# Coastal Access – Marsland Mouth to Newquay lengths MNQ2 and MNQ6

## Representations with Natural England’s comments

**July 2021**

**Document A – MCA/MNQ2/R/6/MNQ0975** map showing the new route of South West Coast Path. Document submitted by Natural England.

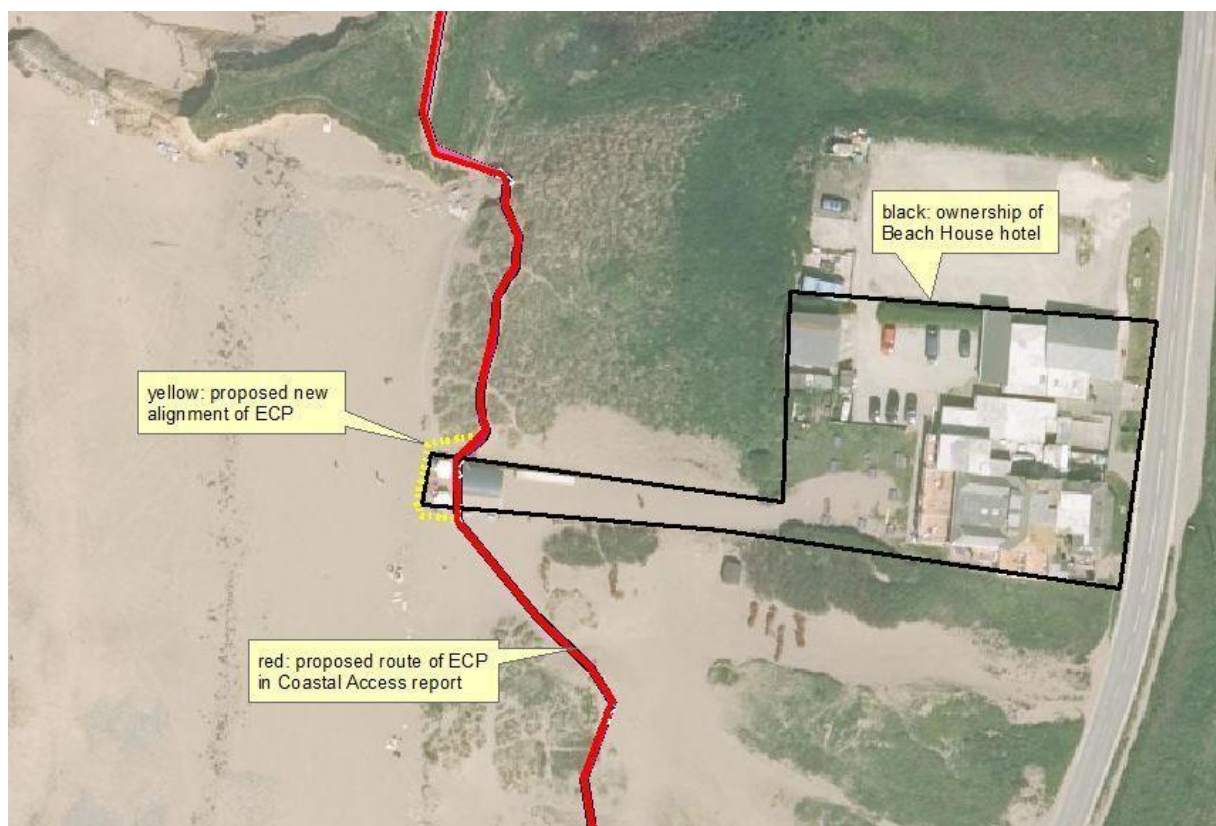
Upton: The existing kissing gate has a clear gap of only 450mm with a puddle both sides, making it difficult to use, particularly for walkers carrying a large rucksack. The kissing gate should be removed or replaced with one which complies with BS5709:2018 with a 1000mm gap and the surface improved.

Since publishing our coastal access report MNQ2, the Access Authority has realigned the route of the South West Coast Path (SWCP) to avoid the eroding cliffs seaward of Upton Terrace cottages (see document A in section 5 below). This predicted change was noted in section 2.2.18 of report MNQ2. Therefore the kissing gate referred to in the representation has become redundant.

Our proposed route along sections MNQ-2-S059 and MNQ-2-S060, map MNQ2d, is now no longer viable and we support a modification to the England Coast Path to follow the new walked route of the SWCP. An objection from the landowner (see objection MCA/MNQ2/O/1/MNQ0638) has been received on this subject and we have made a recommendation to modify the route in this way in response to that objection.
